COMMUNICATION EQUIPMENT MAINTENANCE BULLETIN

SECTION 8. RECEIVING EQUIPMENT

FIGURE 1.—Modification of power pack of model RU receiving equipment.

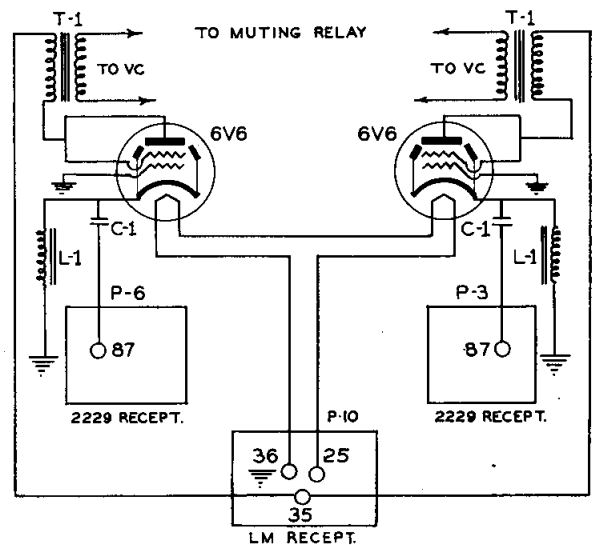
RU receivers and a-c power packs have been received and installed in various Naval Air Activity Control Towers. At the Naval Air Training Bases, Corpus Christi, Tex., it was found necessary to modify the a-c power pack in order to bring each receiver output up to loud speaker volume. The modification was made as illustrated in Figure 1.

— CHANGE R-10 IN GF-RU-LM POWER SUPPLY TO A 5000Ω 10 WATT RESISTOR

FIGURE 1.—Contents of kit.

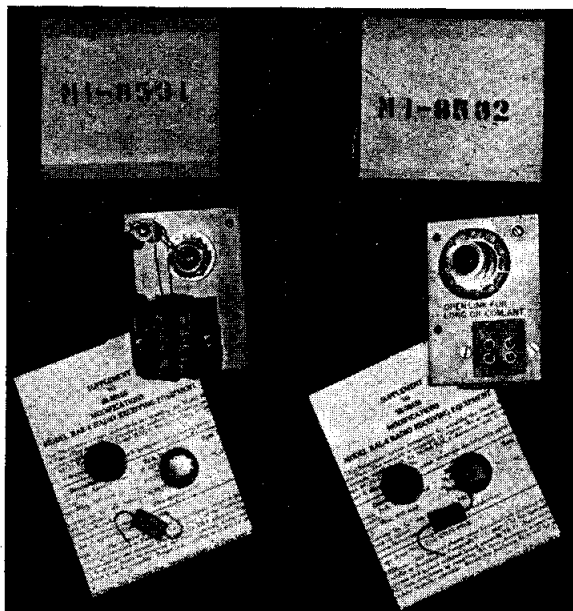
Each modification kit contains two complete assemblies as shown in Figure 1; one (MI-8531) is for the model RAK-6, and one (MI-8532) for the model RAL-6. The two assemblies are identical except for the coupling capacitor, symbol C-101. This capacitor has a rating of 300 mmfd. on the RAK-6 assembly and 440 mmfd. on the RAL-6 assembly. One spare coupling capacitor is furnished for each assembly and should be placed in the respective receiver spare parts boxes. The two plug buttons supplied with each assembly are to be inserted in the two binding-post holes in the cabinet which are not required after installation of the new assembly.

The modification consists, basically, of removing the present binding-post-type antenna terminal board assembly and replacing it with the new concentric jack type assembly. Complete instructions and diagrams are packed with each kit and should be carefully followed. These instruction sheets should be inserted in the respective instruction books after completion of the modifications.

FIGURE 2.—Revised first and second i-f stages.

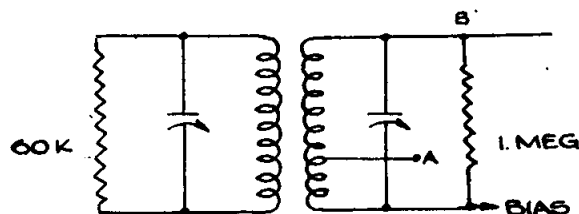
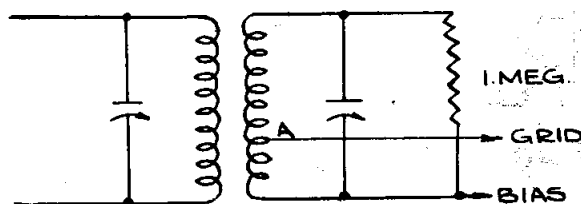
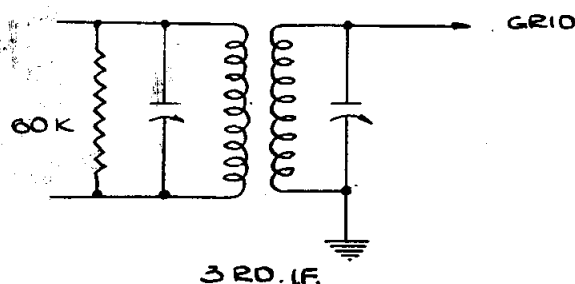
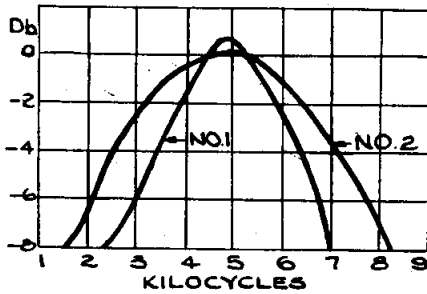
The following method of broadening the i-f response by overcoupling is known as Navy Yard Pearl Harbor plan No. RV-46-A-124. The modification just described is preferred to this modification. In addition, it is pointed out that this is a delicate modification and should not be attempted except in a laboratory. It was accomplished as follows:

was increased by decreasing the distance between the primary and secondary coils from $1\frac{1}{2}$ " to $\frac{7}{16}$ ". It was necessary to apply heat to the porcelain coil form to accomplish the movement of the primary coil.

(2) The secondaries of the first and second stage intermediate-frequency transformers have a tap to which the grid was connected in the original installation as shown at "A" in Figure 1. The grid connection was removed from this tap and attached to the extreme end of the coil which

is connected to the stator plates of the trimmer condenser as shown at "B" in Figure 2.

(3) A 1/2-watt resistor of 60,000 ohms was connected in parallel with the primary circuit of each i-f stage, as shown in Figures 2 and 3.

(4) Selectivity before and after modification is shown in Figure 4.

FIGURE 1.—Main tuning condenser assembly.

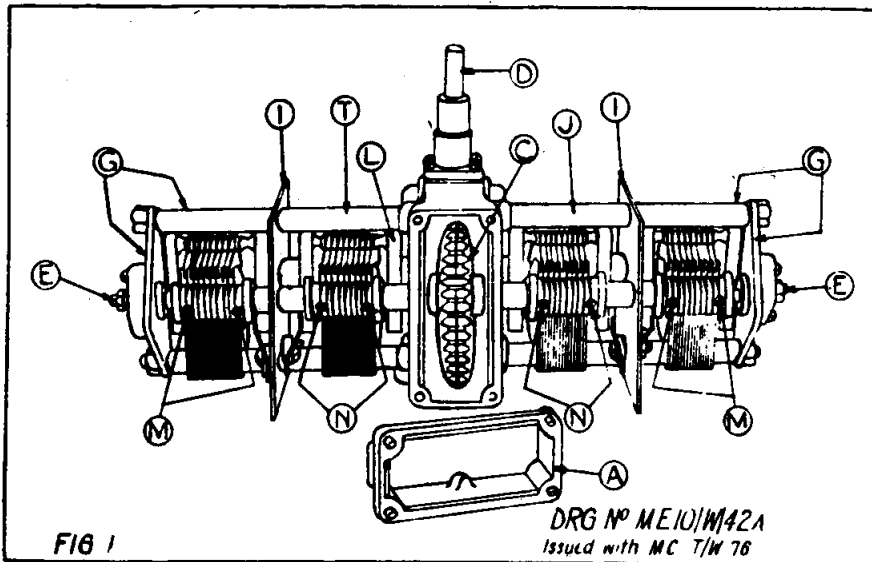
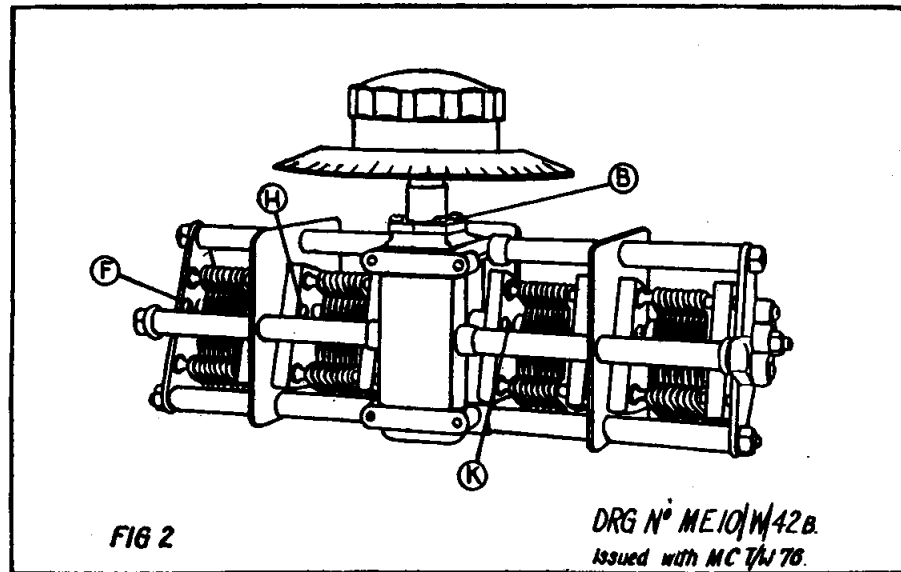
(6) Remove four screws retaining gear case top cover Figure 1 (A) and four screws retaining gear case cover Figure 2 (B).

(7) Bind a single loop of #12 B & S copper wire across teeth of large gear wheel Figure 1 (C) to retain the two halves in position; remove drive spindle Figure 1 (D) complete with thrust spring and two washers.

(8) Slacken off bearing screws Figure 1 (E) and remove three nuts from each plate.

(9) Remove two screws securing outer stator insulator bars to end plates Figure 2 (F).

(10) Remove end plates and spacing pieces, Figure 1 (G).

(11) Loosen Allen set screws securing outer rotors Figure 1 (M) to spindle and remove rotors taking care not to distort vanes.

(12) Remove screws securing inner stator insulator bars to screens Figure 2 (H).

(13) Remove screens complete with outer stators attached Figure 1 (I) and spacing pieces Figure 1 (J).

(14) Remove screws securing inner stator insulator bars Figure 2 (K) to gear box.

(15) Remove inner stators Figure 1 (L).

(16) Loosen Allen set screws securing inner rotors Figure 1 (N) to spindle and remove rotors, taking care not to distort vanes.

FIGURE 1.—Installation of 50063 preselector.

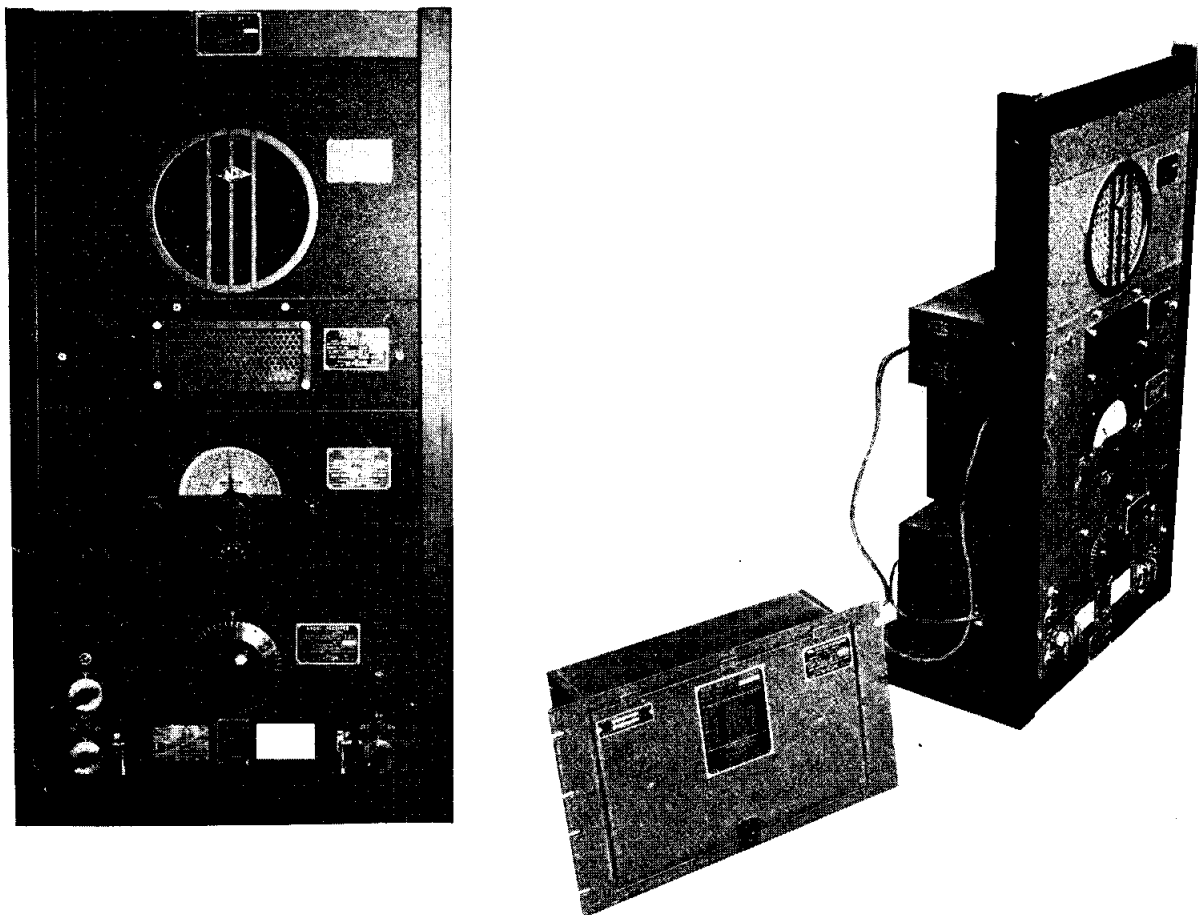
A standard relay rack panel is drilled to accommodate the dial and knobs of the preselector and the unit is installed behind the panel as

shown in figure 1. The coil container is removed from the rack and installed elsewhere in a convenient location.

FIGURE 1.—Installation of plug adapter.

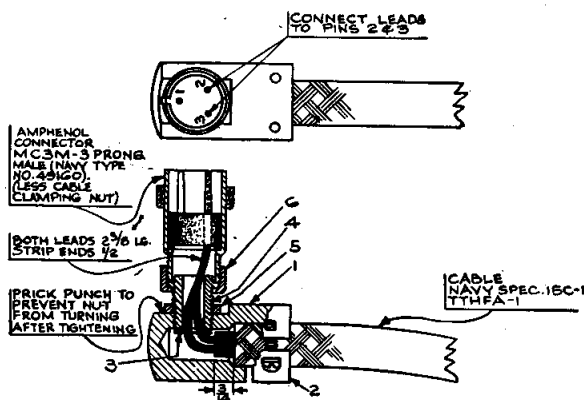
Procedure.—The plug adaptor is to be installed in the following manner: (The numbers, in brackets, referenced throughout the text, refer to Fig. 1.)

(2) Strip $\frac{1}{2}$ " off the ends of the two conductors as shown in Figure 1.

(6) Assemble bushing [4], locknut [5], coupling nut [6] and plug, Navy type CPH-49160. Insert the conductor leads into pins no. 2 and no. 3, as shown in Figure 1.

(7) Before tightening the locknut [5] note positions of the key and connections. Be sure that the positions agree with Figure 1. Tighten the locknut [5].

FIGURE 1.—Installation of plug adapter.

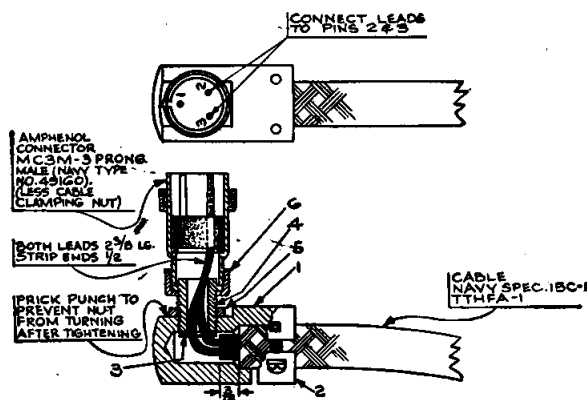
Procedure.—The plug adapter is to be installed in the following manner: (The numbers, in brackets, referenced throughout the text, refer to Fig. 1).

(2) Strip $\frac{1}{2}$ " off the ends of the two conductors as shown in Figure 1.

(6) Assemble bushing [4], locknut [5], coupling nut [6] and plug, Navy type CPH-49160. Insert the conductor leads into pins no. 2 and no. 3, as shown in Figure 1.

(7) Before tightening the locknut [5] note positions of the key and connections. Be sure that the positions agree with Figure 1. Tighten the locknut [5].

FIGURE 1.—RBB/RBC receivers band switch stators—before and after modification.

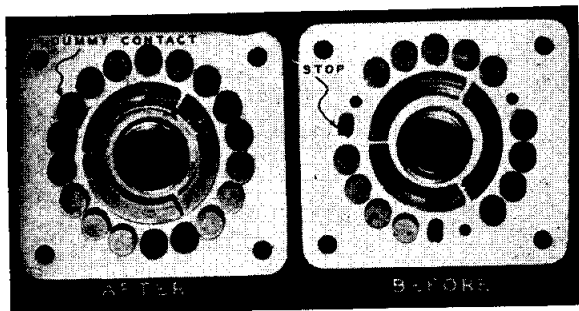
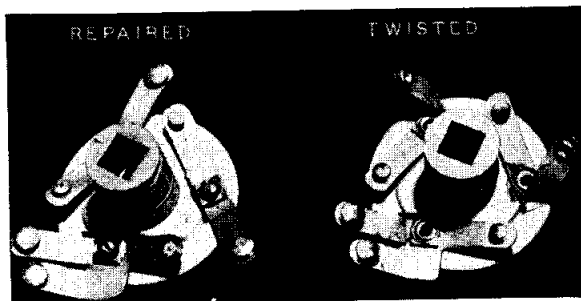
Purpose.—To prevent the band switch rotor contacts from twisting.

Procedure.—Equipments should be modified as shown in the accompanying photographs, Figures 1 and 2. The modification, which was

suggested by C. E. Swiger, RT 1/c of the U. S. S. *Cascade* (AD-16), consists of removing the stop pins and filling the holes on the band switch with plugs made of bakelite or other suitable insulating material. The plugs should be made as shown, having approximately the same top dimensions as the switch contact points. It is believed that the photographs are self-explanatory.

FIGURE 1.—Installation of plug adapter.

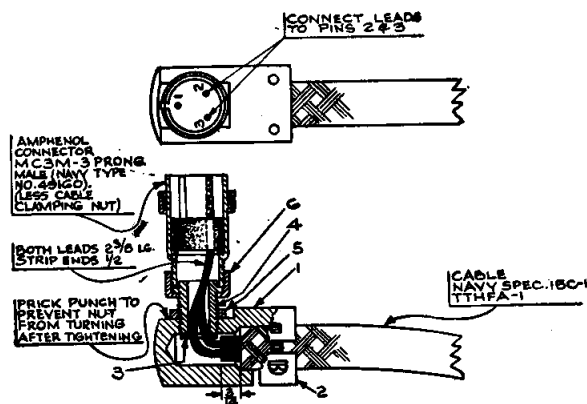
Procedure.—The plug adaptor is to be installed in the following manner: (The numbers, in brackets, referenced throughout the text, refer to Fig. 1).

(2) Strip $\frac{1}{2}$ " off the ends of the two conductors as shown in Figure 1.

(6) Assemble bushing [4], locknut [5], coupling nut [6] and plug, Navy type CPH-49160. Insert the conductor leads into pins no. 2 and no. 3 as shown in Figure 1.

(7) Before tightening the locknut [5] note positions of the key and connections. Be sure that the positions agree with Figure 1. Tighten the locknut [5].

FIGURE 1.—RBB/RBC receiver band switch stator—before and after modification.

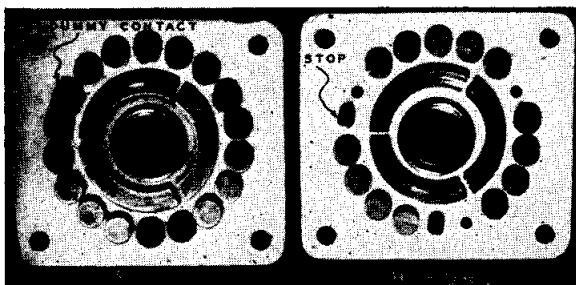
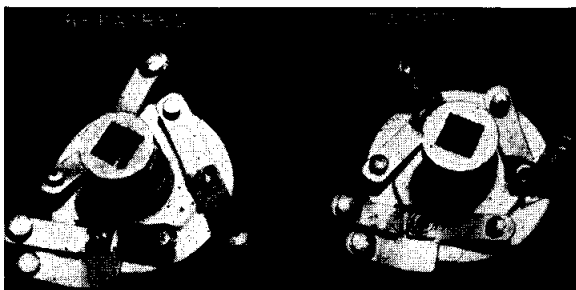
Purpose.—To prevent the band switch rotor contacts from twisting.

Procedure.—Equipments should be modified as shown in the accompanying photographs, Figures 1 and 2. The modification, which was

suggested by C. E. Swiger, RT 1/c of the U. S. S. *Cascade* (AD-16), consists of removing the stop pins and filling the holes on the band switch with plugs made of bakelite or

other suitable insulating material. The plugs should be made as shown, having approximately the same top dimensions as the switch contact points. It is believed that the photographs are self-explanatory.

FIGURE 1.—Modification of model RBH-1 to provide carrier-controlled noise suppression action.

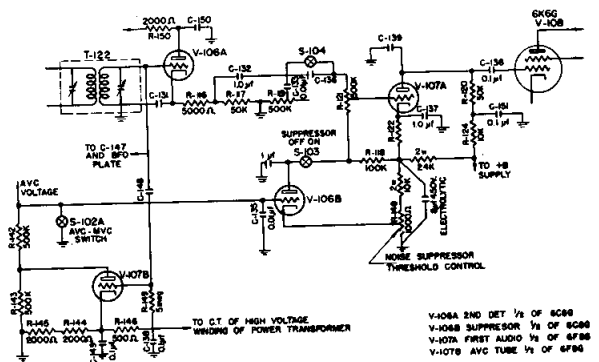
The wiring in the receiver is rearranged in accordance with figure 1, utilizing components already in the receiver as required. Resistor R-148 functions as a noise suppression thresh-

hold control or an adjustment which determines the strength of the incoming carrier necessary to unlock the audio system. Switch S-103 is used to remove the noise suppression feature if desired. The circuit is adjusted by setting the suppressor threshold control so that atmospheric disturbances are just barely eliminated with the r.-f. gain full on and no carrier being received. The suppressor circuit is highly

FIGURE 1.—Installation of plug adapter.

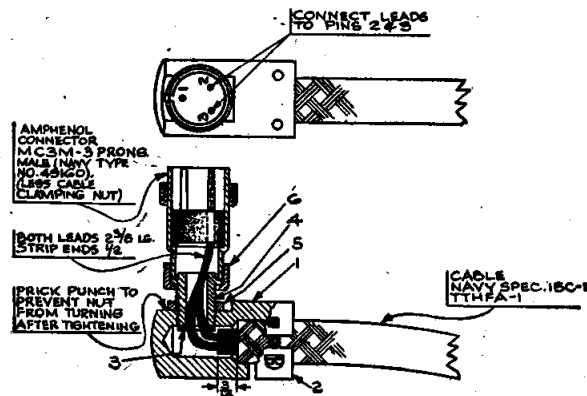
Procedure.—The plug adapter is to be installed in the following manner: (The numbers, in brackets, referenced throughout the text, refer to Fig. 1.)

(2) Strip the ends of the two conductors $\frac{1}{2}$ " as shown in Figure 1.

(6) Assemble bushing [4], locknut [5], coupling nut [6] and plug, Navy type CPH-49160. Insert the conductor leads into pins no. 2 and no. 3, as shown in Figure 1.

(7) Before tightening the locknut [5] note positions of the key and connections. Be sure that the positions agree with Figure 1. Tighten the locknut [5].

FIGURE 1.—Response curve and modified schematic for Model RCK receiver.

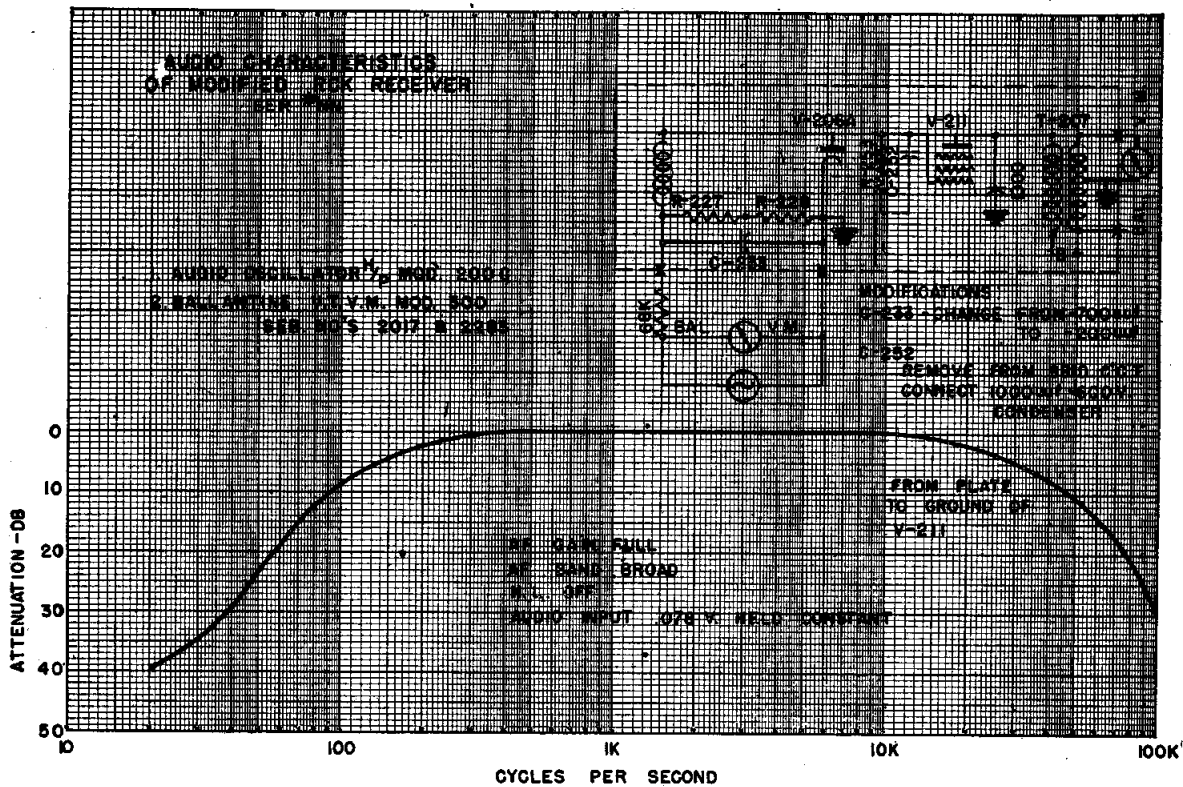
All references to capacitor C-233 in the Model RCK instruction book as a 700-mmf capacitor should be corrected in ink to read as a 200-mmf capacitor.

All wiring diagrams in the Model RCK instruction book which include tube V-211 should have the above mentioned 1,000-mmf, 600-volt capacitor drawn in ink between the plate and ground of this tube.

These changes will provide a response very closely approximating that shown in figure 1 on the preceding page.

FIGURE 1.—Field change No. 1 to the model RDP panoramic adaptor.

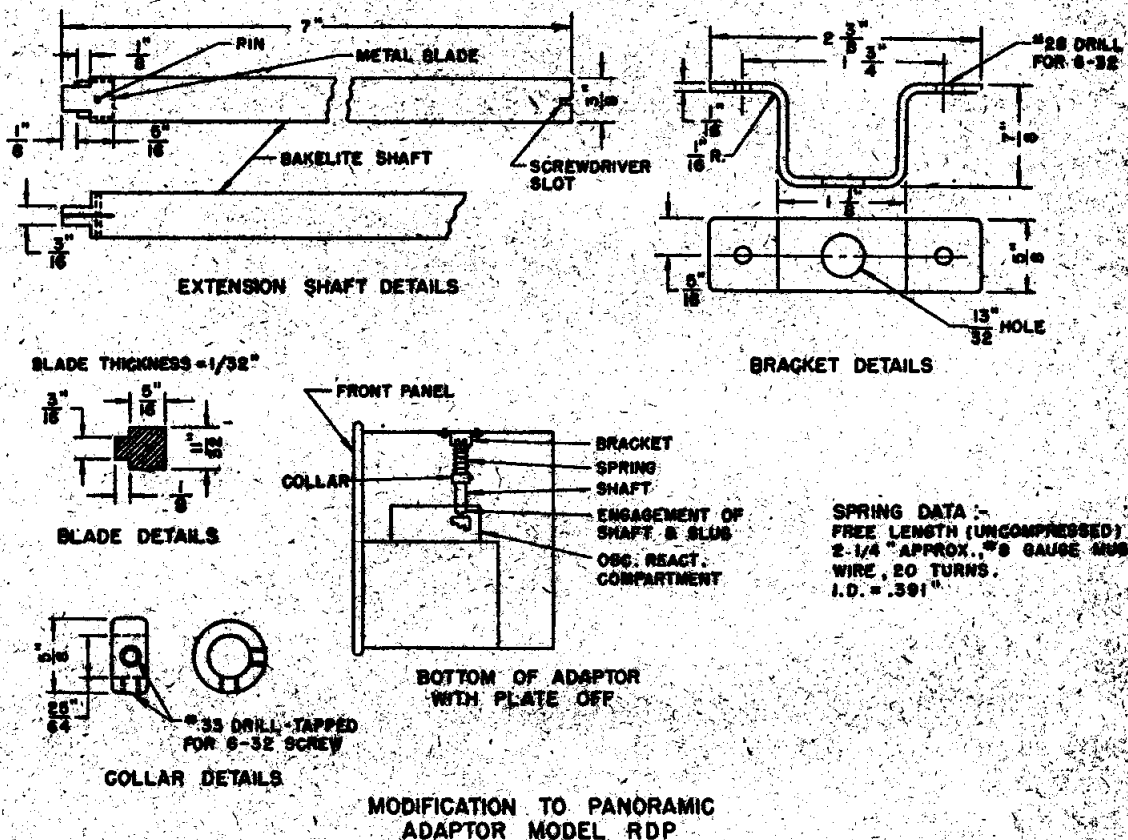
Purpose.—To alleviate alignment difficulties and safeguard personnel.

chassis, and the other end of the shaft is supported by its insertion into the tuning slug assembly. The bracket is mounted by means of 6-32 screws and bolts, for which holes are drilled through the side of the chassis with a #28 drill. A third hole, $1\frac{1}{32}$ -inch in diameter, permits access to the screwdriver slot in the extension shaft. Spring loading is provided

Procedure.—Details of this modification are shown in Figure 1. Minor alterations may be made to meet the particular needs of the activity making the modification.

Figure 1.—The Crystal oven and the two identifying screws.

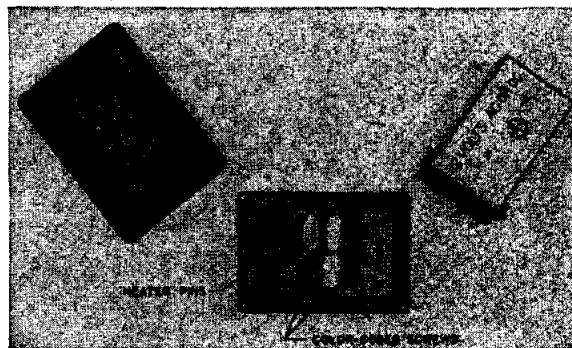
Figure 1 shows the oven and the two identifying screws.

Crystal ovens of the old type should be returned to the Electronics Officer for replacement with the new improved ovens. Electronics Officers should ascertain that new improved ovens are provided for all model RDZ, MAR and TDZ equipments before installation. The spare parts should also be checked for inclusion of the new oven. 6/1/46

FIGURE 1.—Modification of mixer inductance trimmer to reduce value of the inductance.

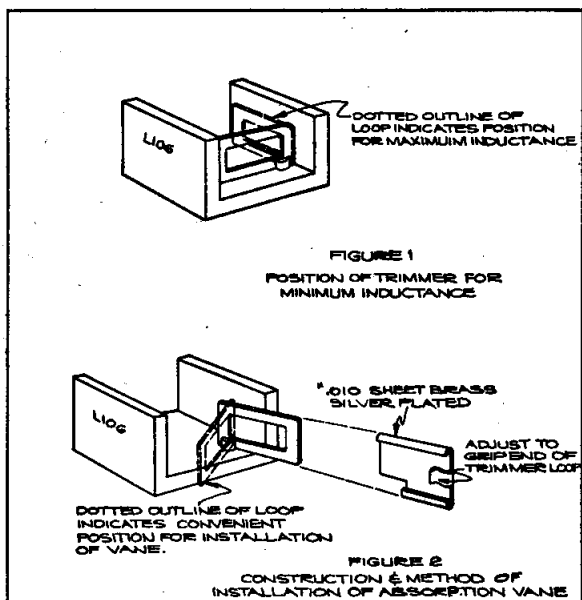
2. Remove shield plates from the last multiplier mixer compartment. Determine by inspection the setting of the mixer inductance. If this trimmer is at minimum inductance setting (see fig. 1 of accompanying sketch) or within 30° of minimum (inside the inductance) it will be necessary to install the absorption vane on the trimmer as shown in figure 2 of the accompanying sketch. If the trimmer setting is 30° or more from the minimum position, the absorption vane is not necessary.

(3) Replace shields and select a convenient channel frequency on the receiver from 250 to 260 mc. Tune a signal generator to the receiver. Allow time enough for receiver and generator to stabilize and recheck generator frequency.

FIGURE 2.—Model RBK-14 modification.

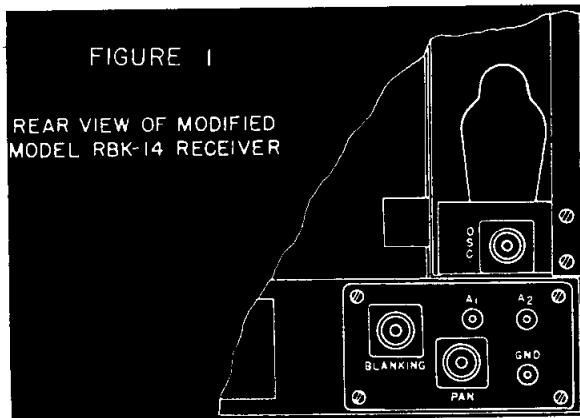
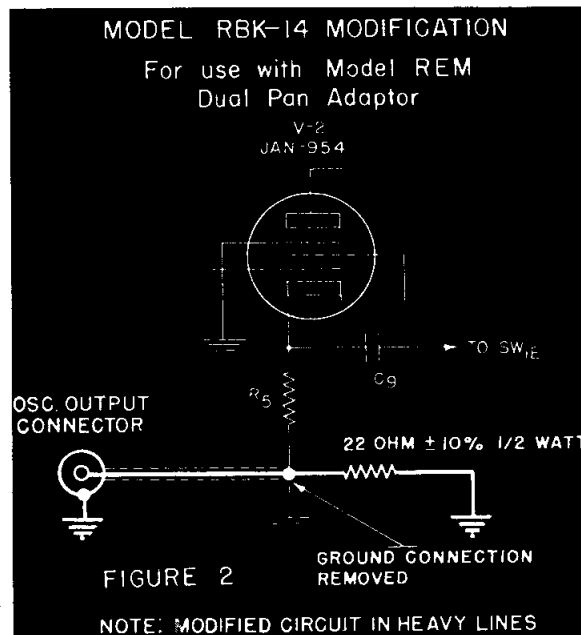
To use the Model REM to the fullest extent requires that the Models RAO-9 and RBK-14 countermeasures receivers supply local oscillator voltage to the Model REM so as to produce marker pips on the pan presentation. The Model RBK-14 receivers have been so modified by the manufacturer and are supplied with an oscillator output connection. (See Figure 1.) The Model RBK-14 circuit was modified as shown in Figure 2. The instruction book circuit diagram and the circuit diagram on the inside of the cover of the receiver do not show that this change has been made. They should be corrected accordingly.

the Model REM should be connected into the countermeasures system as shown in the Model REM instruction book, NavShips 91003 (A) minus the cable between the Model RAO-9 oscillator output and the Model RAO-9 oscillator input connector on the Model REM adaptor. The system will operate satisfactorily but minus the advantage of the marker pips.
